City of Portland CRC Refinement Work Portland Freight Committee

June 3, 2010

URS

LANE REDUCTION CONCEPTS

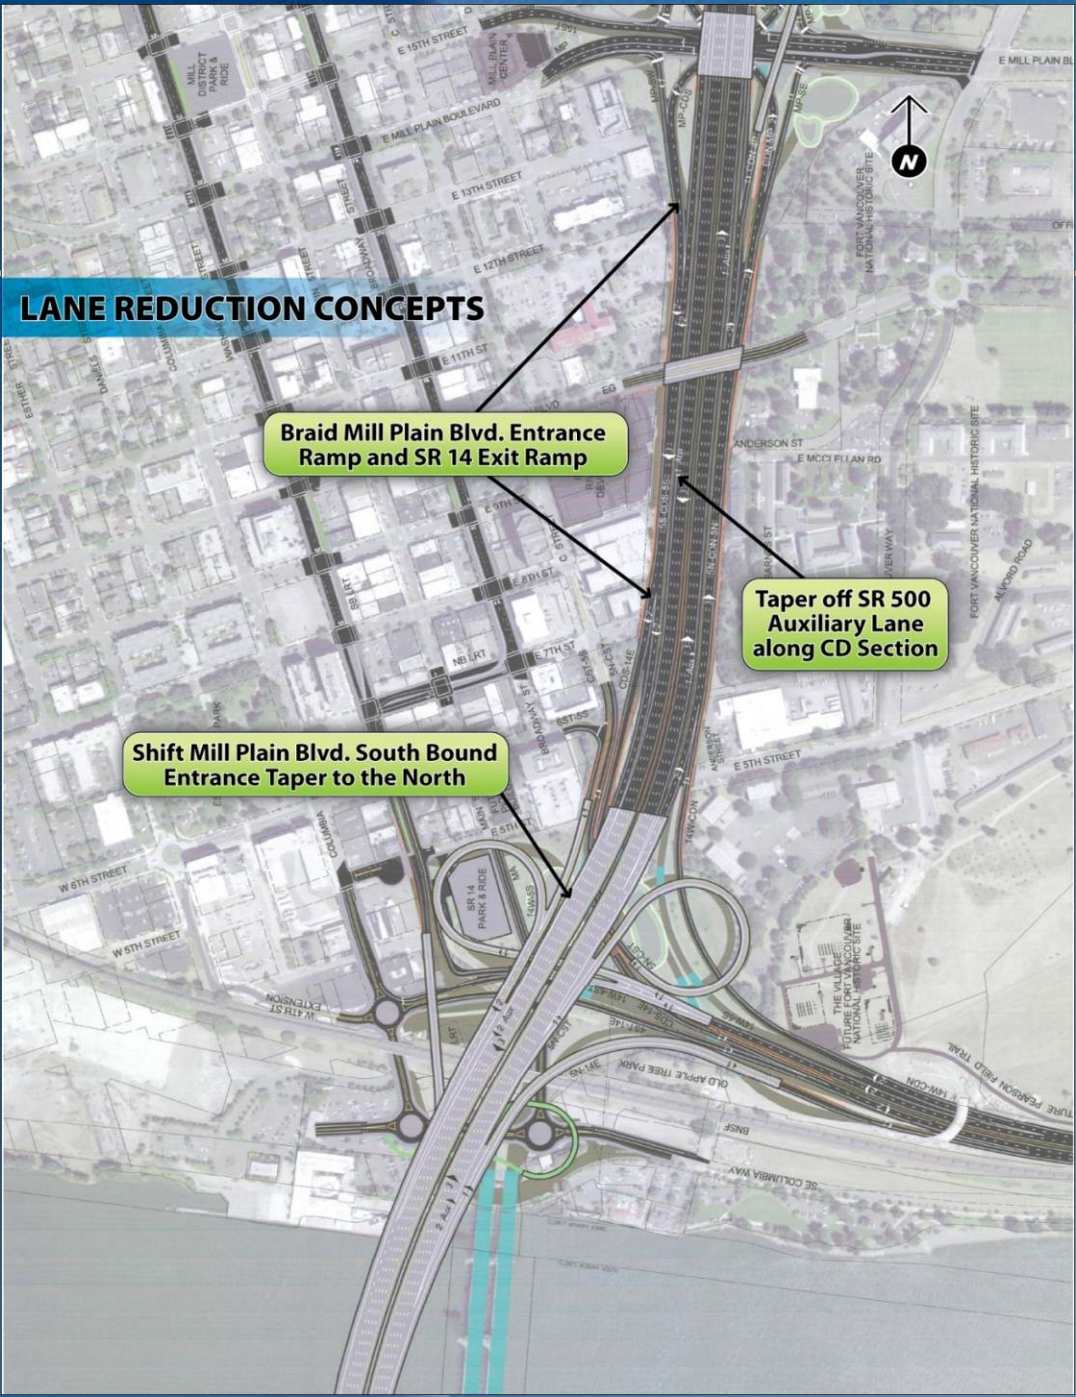
Reducing southbound lanes (options identified)

- Taper SR 500 Auxiliary Lane at CD Section
- Shift Mill Plain SB Ramp Taper to the North
- Braid Mill Plain SB Ramp with SR 14 Exit

Braid Mill Plain Blvd. Entrance Ramp and SR 14 Exit Ramp

Shift Mill Plain Blvd. South Bound Entrance Taper to the North

Taper off SR 500 Auxiliary Lane along CD Section

Option 1

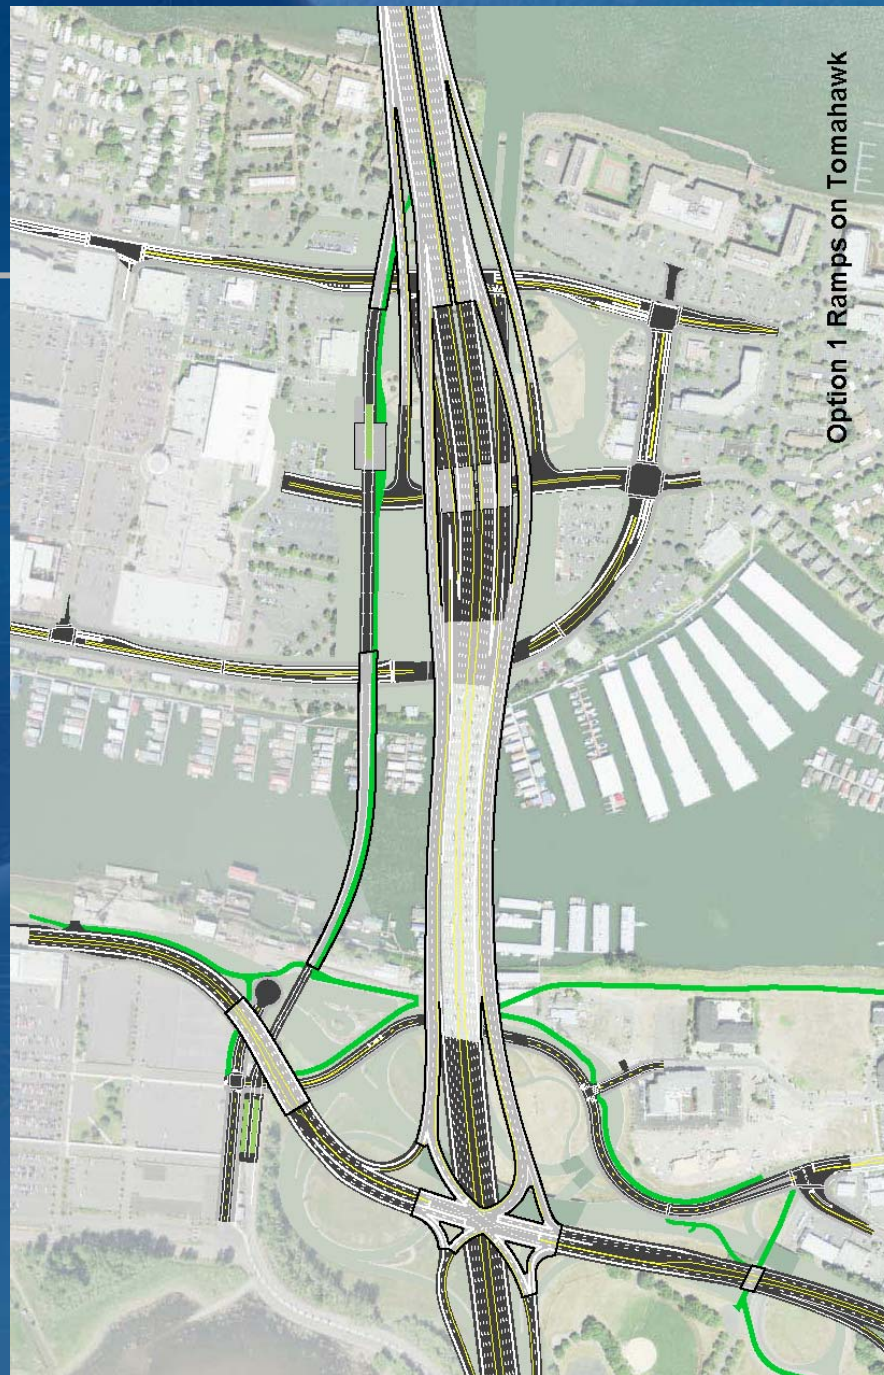
- Investigate design options for reducing the size and impact of the highway facilities on Hayden Island.
- Consider design modifications to the current interchange on Hayden Island with relocated ramp locations and changes in the local street network.
- Consider elimination of the Hayden Island interchange ramps with island access being provided from the Marine Drive interchange and bridges across the slough.
- Evaluate options based on access, land use plans, system performance, right-of-way and implementation.

Ramps on Tomahawk
